ADDENDUM NUMBER TWO

RE: **Butch Gore Park Renovations**
14550 Harry Savoy Road
St. Amant, Louisiana 70774

2 POLE TO POLE TENSION NETTING SYSTEM
NTS
VIEW-185074807

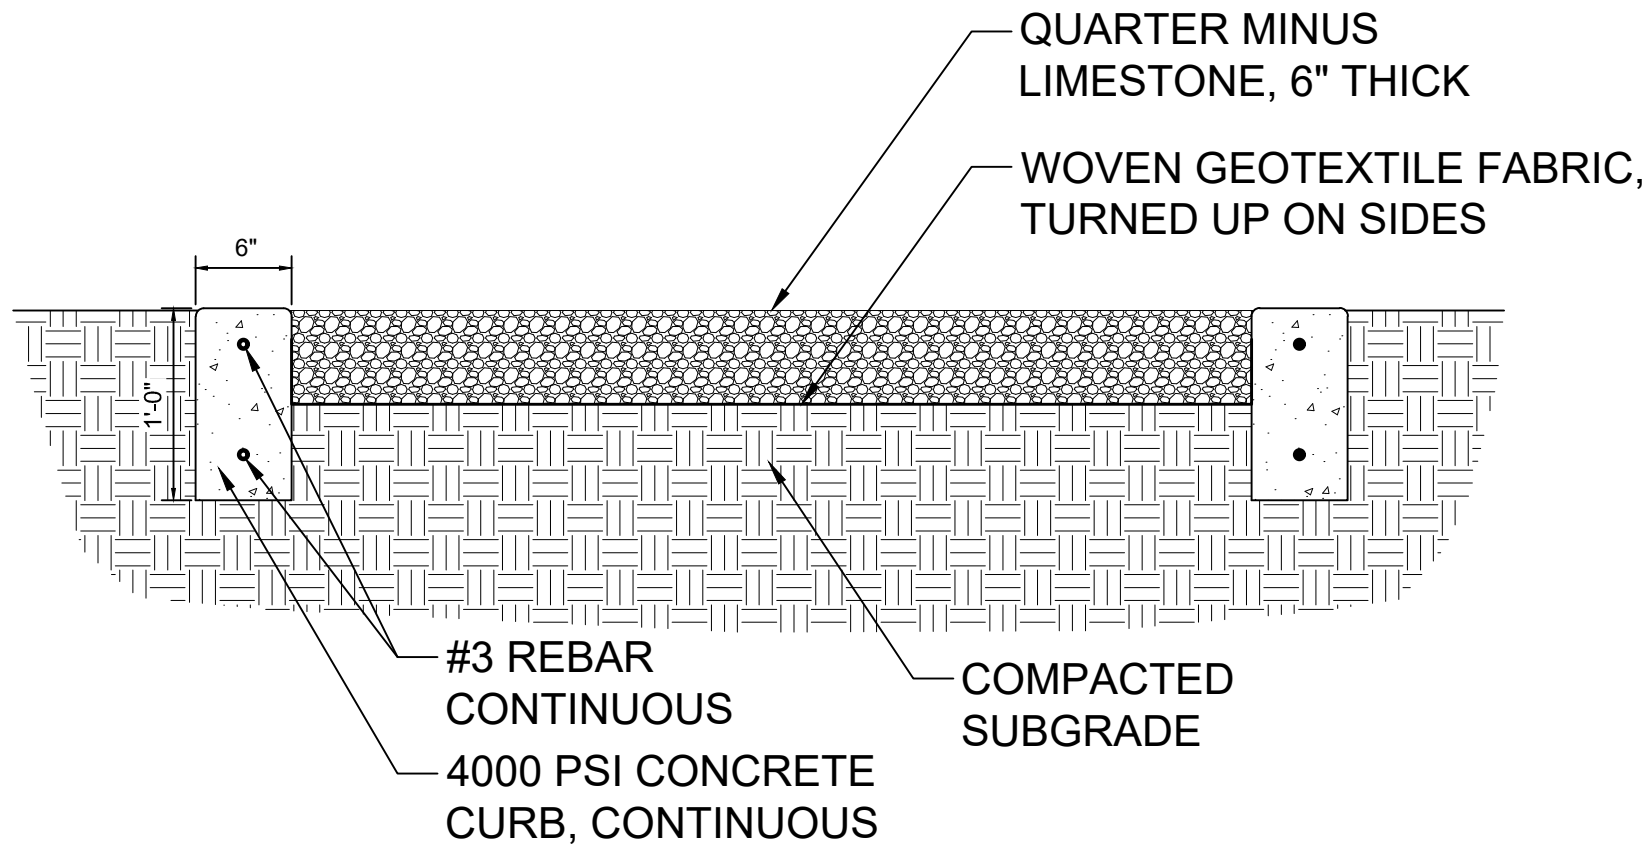
Refer to the attached revised sheet L7.2 for revisions to add additional clarification to backstop netting system details and product information.

BID ADDENDUM 2 - 2023-08-31
CLARIFIED HEIGHT OF BACKSTOP NETTING
